802.3ae™

**Amendment: Media Access Control (MAC)
Parameters, Physical Layers, and Management
Parameters for 10 Gb/s Operation**

IEEE Std 802.3ae™-2002
(Amendment to IEEE Std 802.3™-2002)

Amendment: Media Access Control (MAC) Parameters, Physical Layers, and Management Parameters for 10 Gb/s Operation

Figure 1-1 — IEEE 802.3 standard relationship to the ISO/IEC Open Systems Interconnection (OSI) reference model

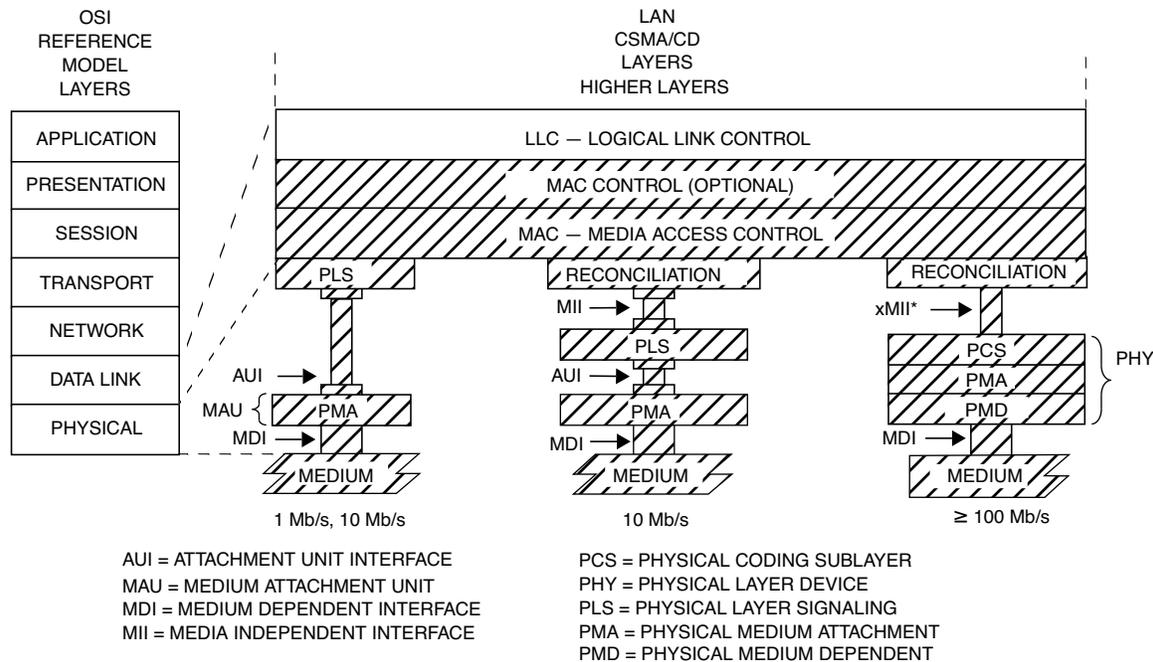
Replace Figure 1-1 with the following:

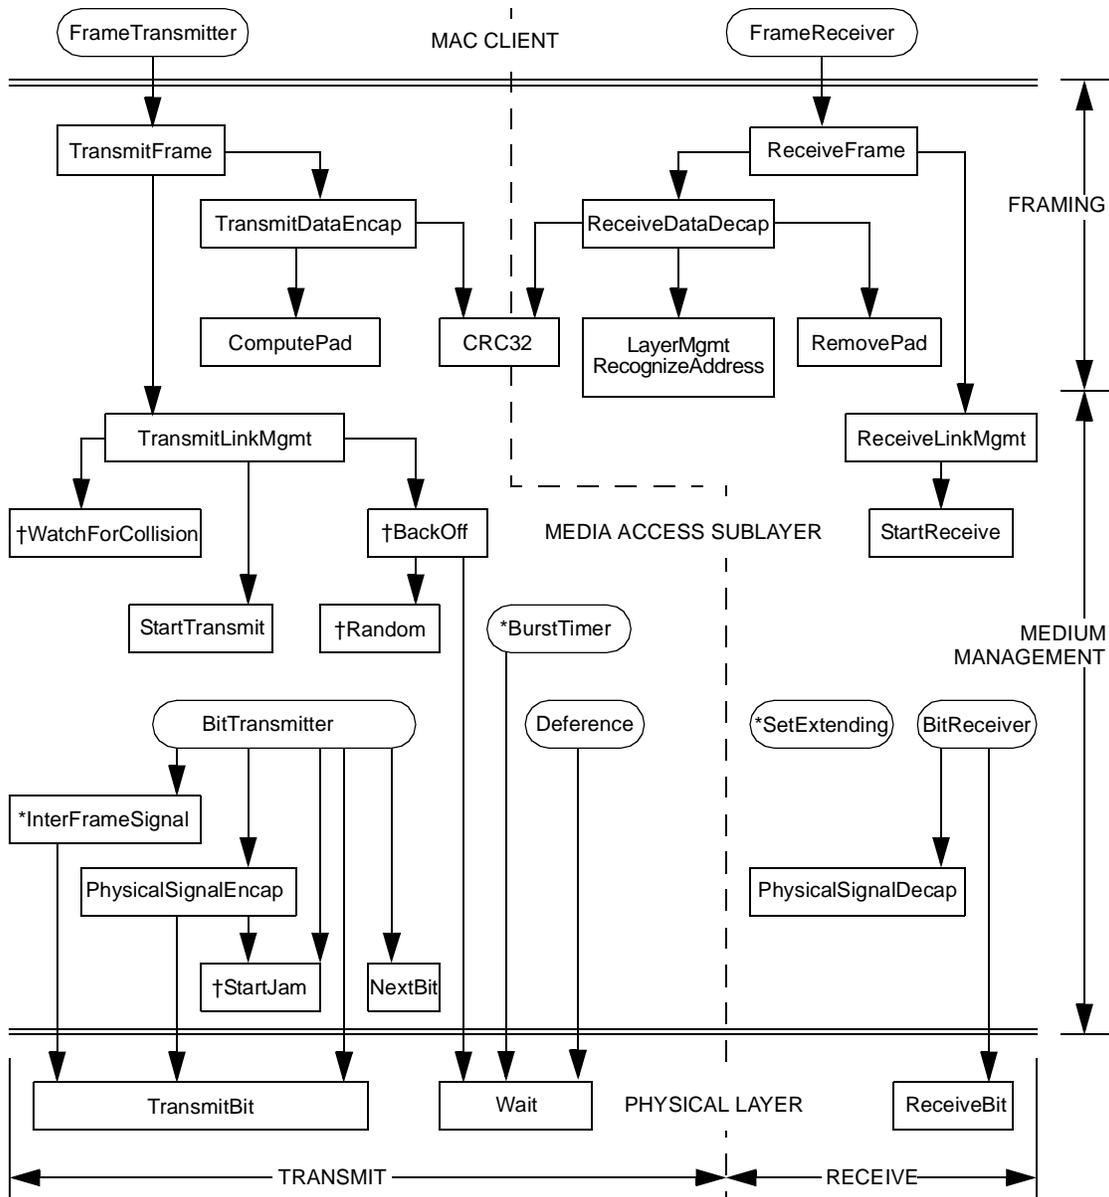
Change Figure 4-5a as follows:

- *Change the figure number from “Figure 4-5” to “Figure 4-4.”*
- *Change the second note to read as follows:*
* Applicable only to half duplex operation at ~~>100~~ >1000 Mb/s.

Figure 6-1 – PLS service specification relationship to the ISO/IEC Open Systems Interconnection (OSI) reference model and the IEEE 802.3 CSMA/CD LAN model

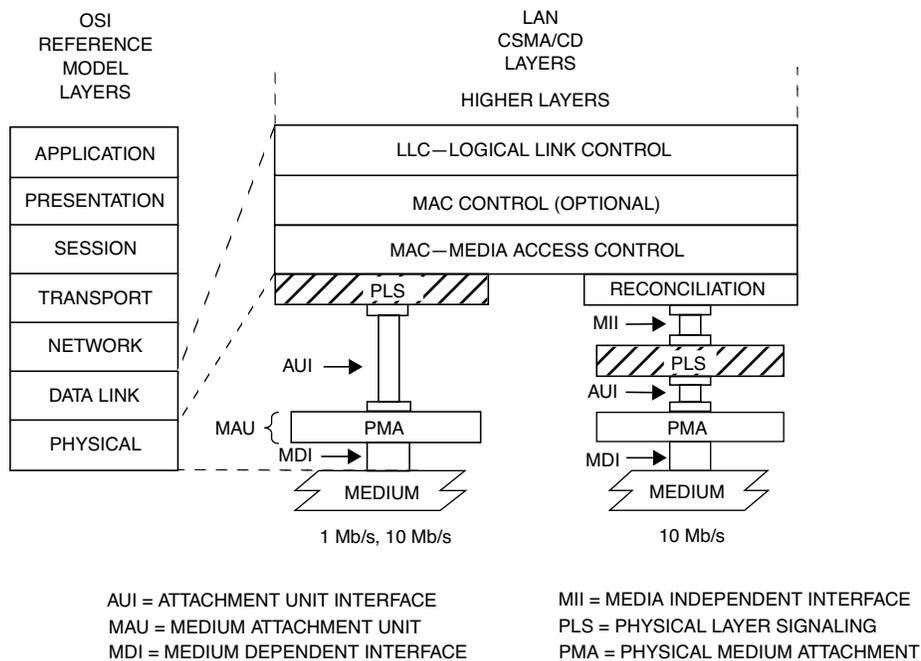
Replace Figure 6-1 with the following:

Figure 22–1 — MII relationship to the ISO/IEC Open Systems Interconnection (OSI) reference model and the IEEE 802.3 CSMA/CD LAN model

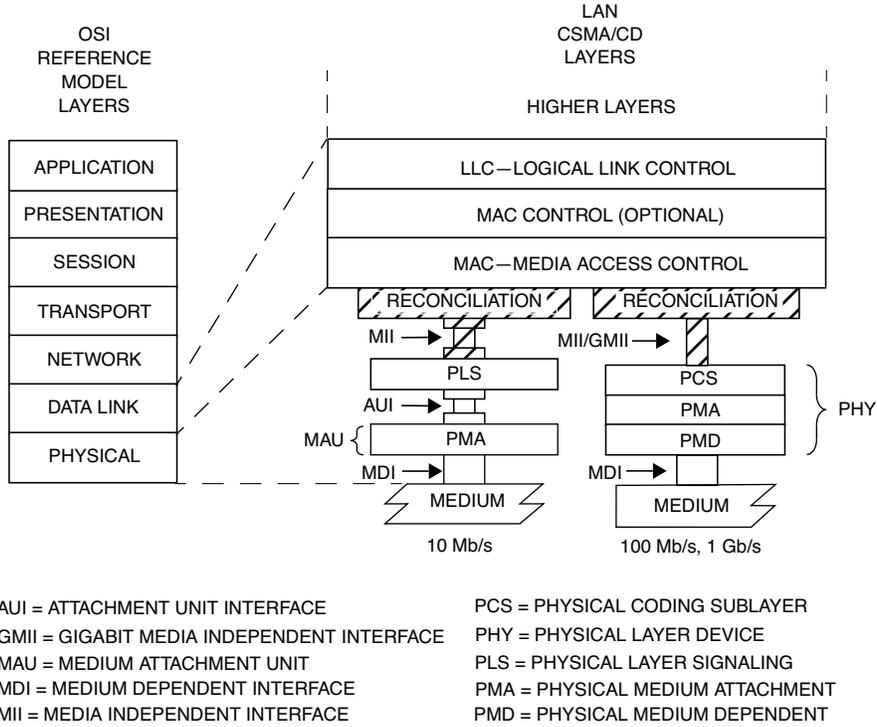
Replace Figure 22–1 with the following:

Figure 30-3—10/100/1000 Mb/s MAC, Control, and Link Aggregation eEntity relationship diagram

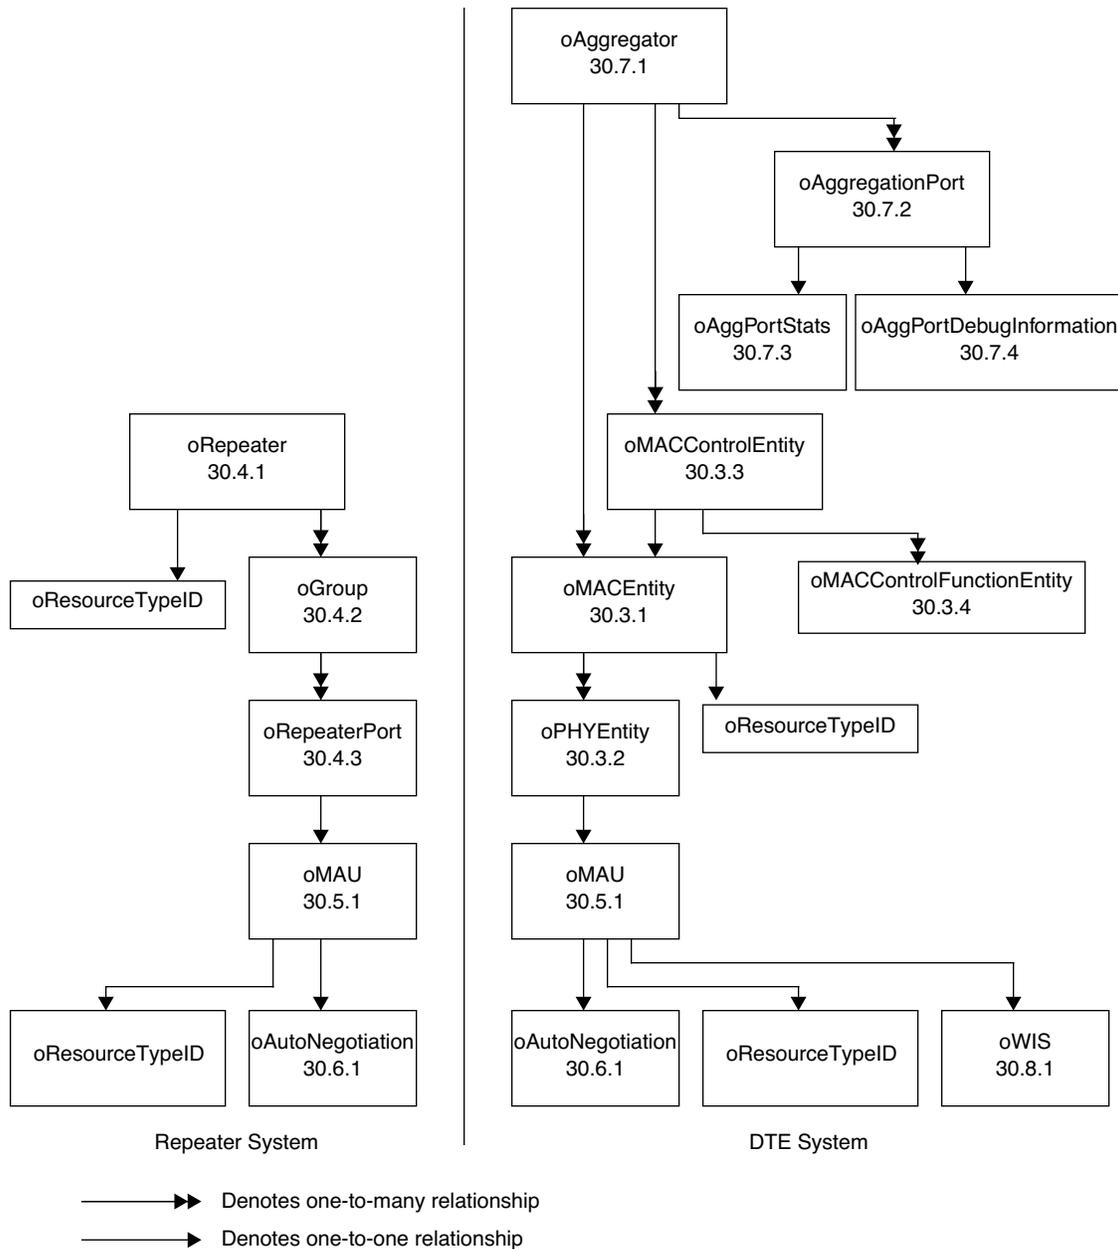
Change the Figure 30-3 as follows:

Figure 35-1 — GMII relationship to the ISO/IEC Open Systems Interconnection (OSI) reference model and the IEEE 802.3 CSMA/CD LAN model

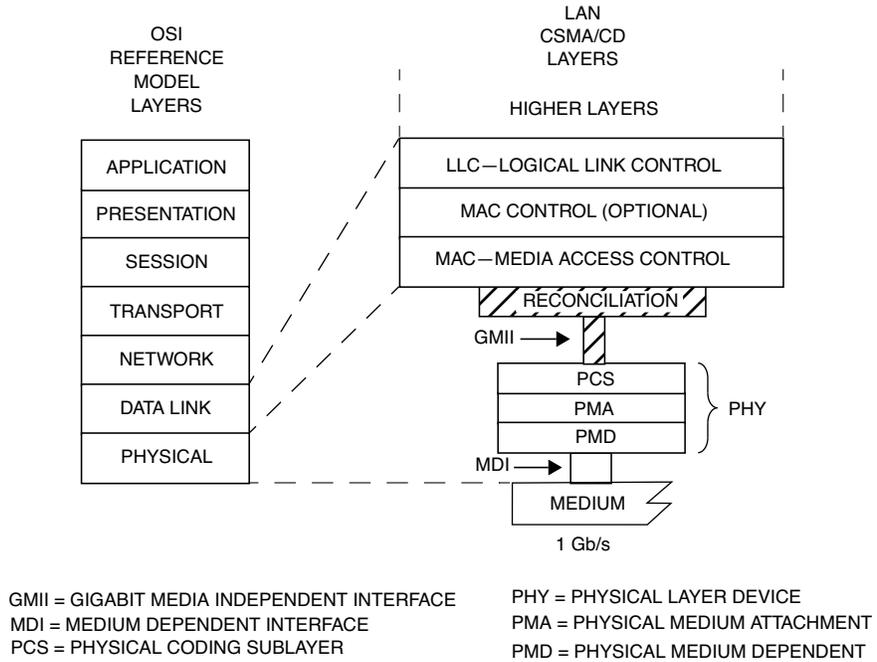
Replace Figure 35-1 with the following:

Figure 31B-1 – PAUSE Operation Transmit state diagram

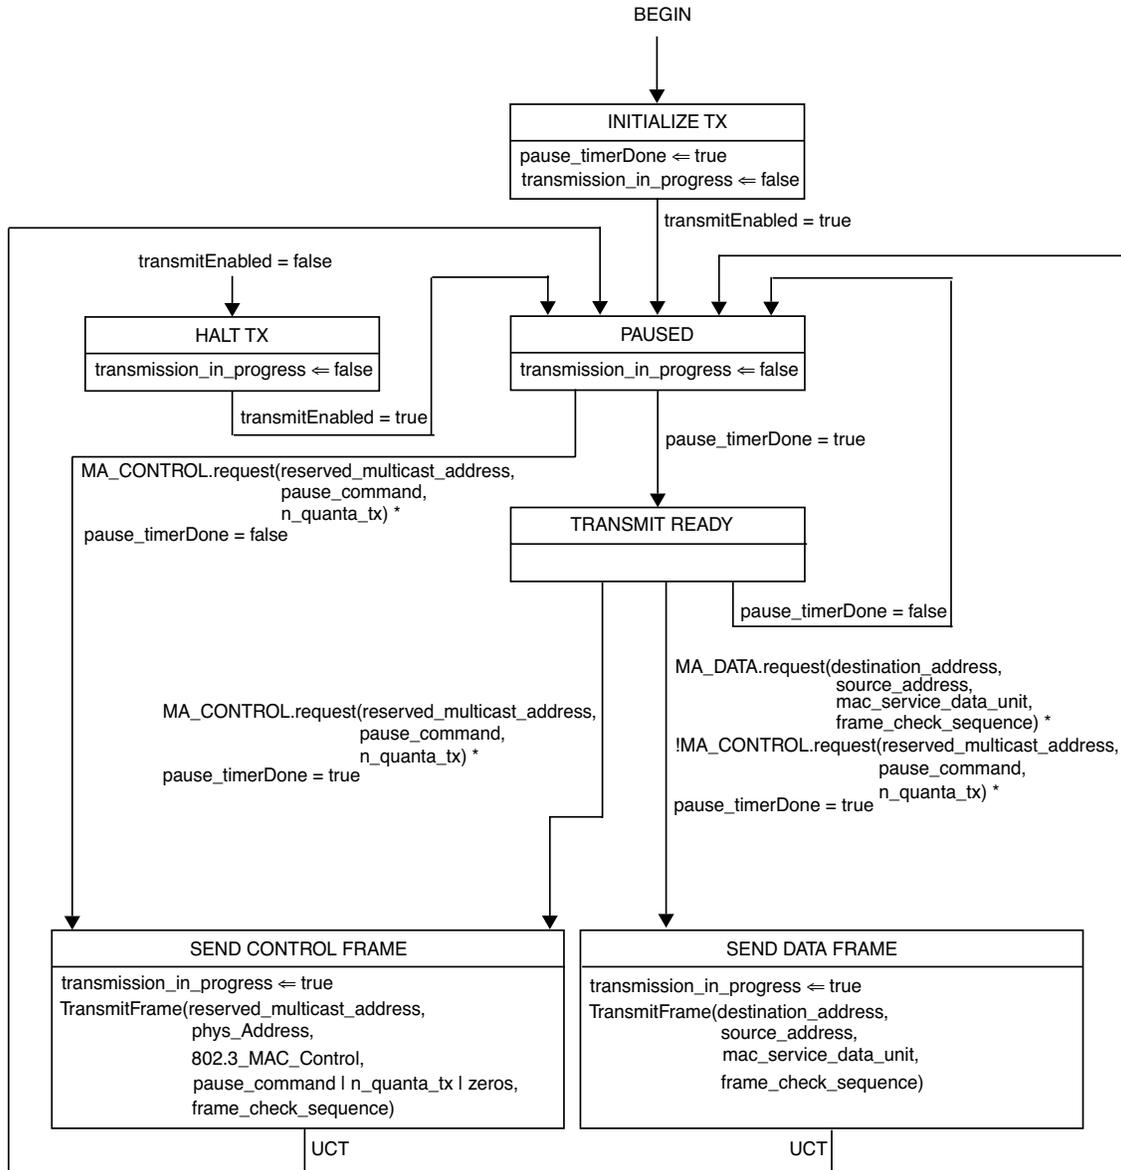
Replace Figure 31B-1 to read as follows:
